UNITED STATES PATENT AND TRADEMARK OFFICE

APPLICATION NO.	FILING DATE	FIRST NAMED INVENTOR	ATTORNEY DOCKET NO.	CONFIRMATION NO.
10/765,969	01/29/2004	Masaki Takabayashi	TAK-168-USAP	2344

Office Action Summary

DETAILED ACTION

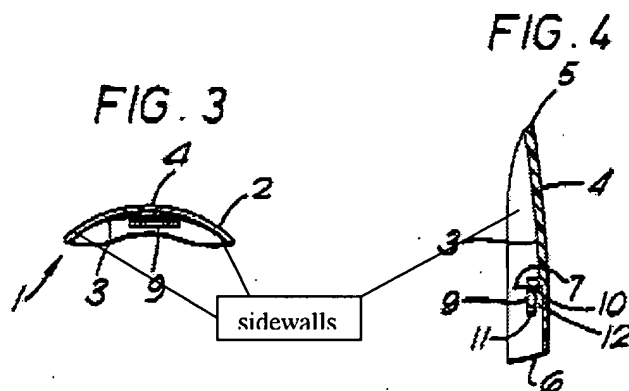
Concerning claims 1, 3, 7 and 9, Aylott ('123) discloses a decorative artificial nail cover (1) which comprises: a cover body (2) extending to an end of the cover with a curved surface like a human nail; and a thin plate wall (9) formed in an inner surface of the cover body and running sideways along the cover body; wherein a fitting ditch (12) is formed on the thin plate wall between the wall and the inner surface of the cover body.

Concerning claims 2, 4, 8 and 10, Aylott ('123) discloses decorative artificial nail cover (1) which comprises: a decorative cover body (2) with a decorative surface (4) and having in a rear portion a pair of side walls (see Figs. 3 and 4 provided herein) directed downward and facing each other; a thin plate wall (9) formed in an inner surface of the cover body and directed toward each side wall; and wherein a fitting ditch (12) is formed on the thin plate wall between the thin plate wall and an inner surface of the cover body.
